AMENDMENTS TO THE DRAWINGS

FIG. 2

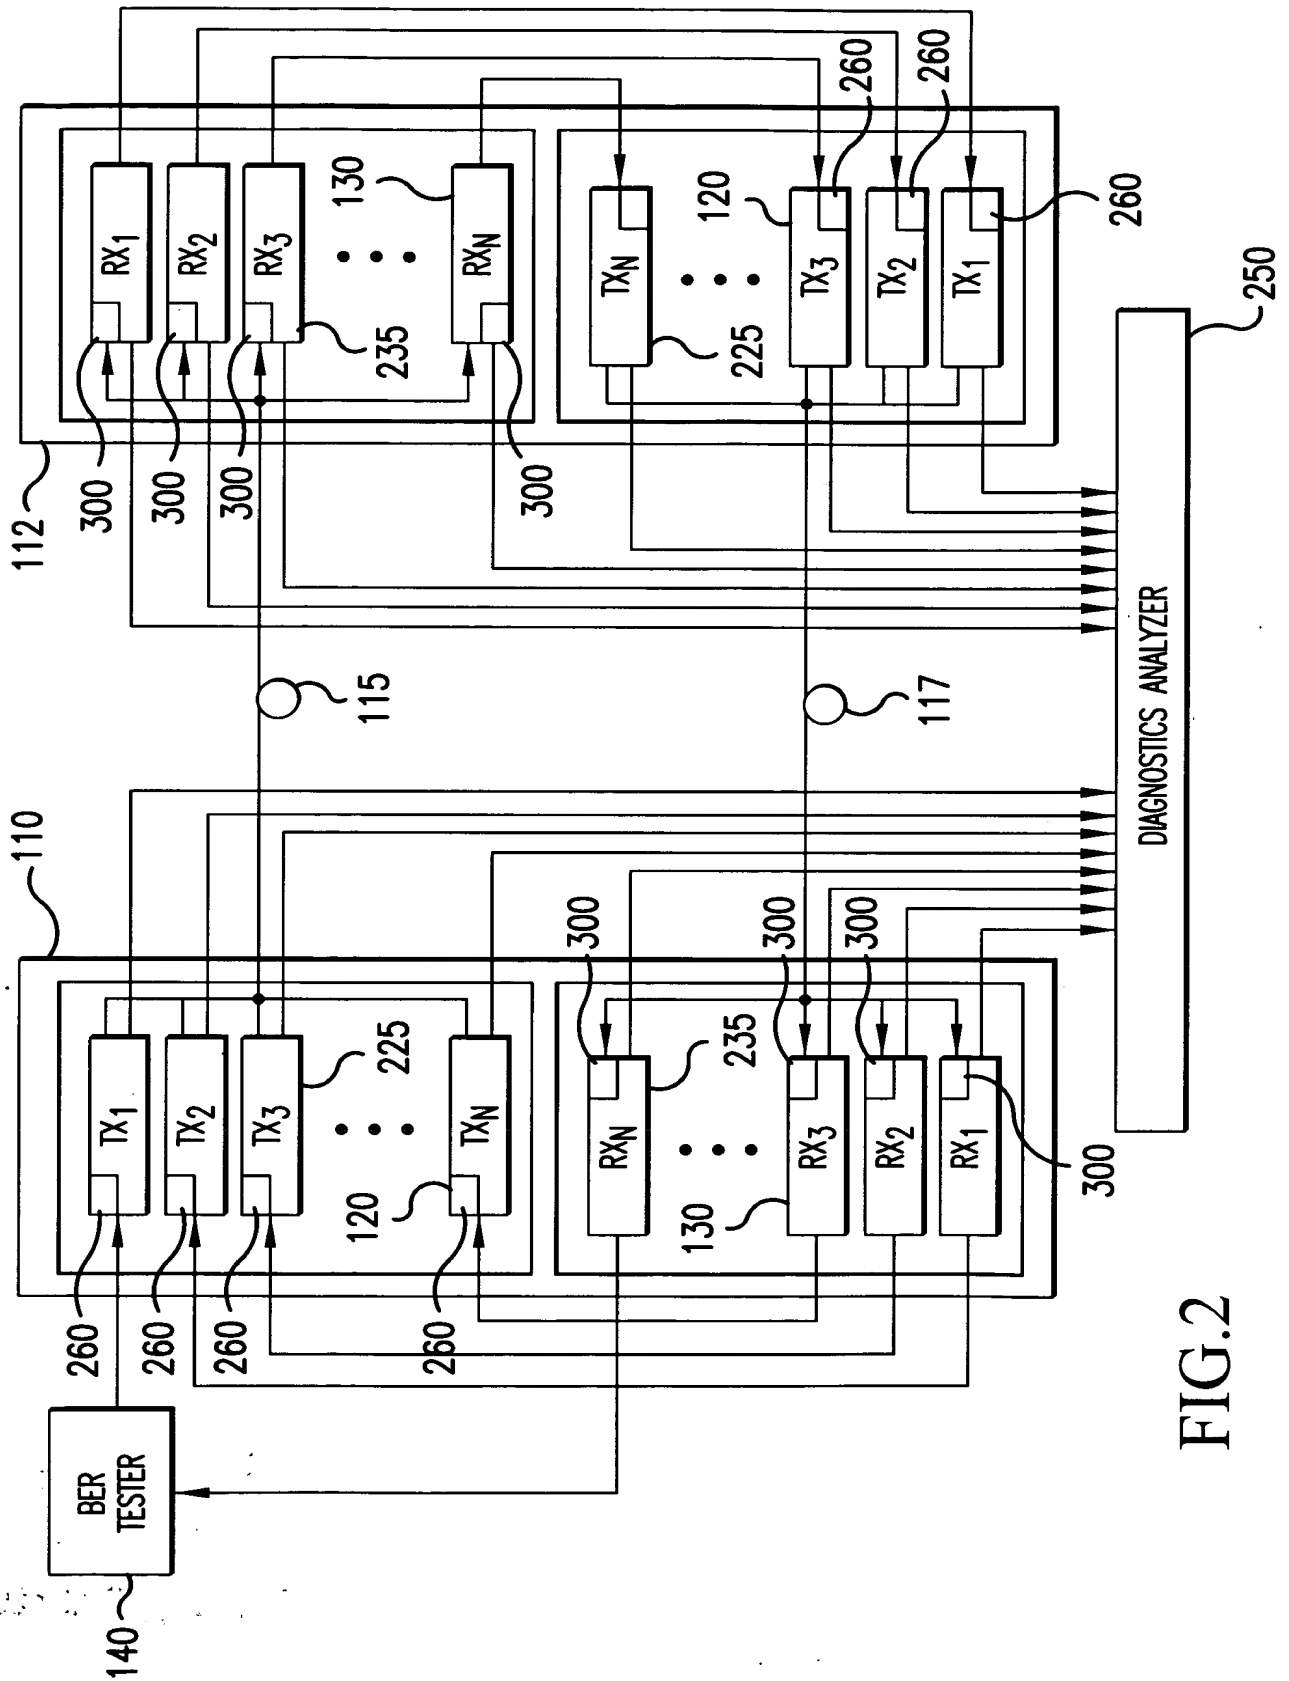
Adding internal performance monitors 260 and 300 to
Figure 2.
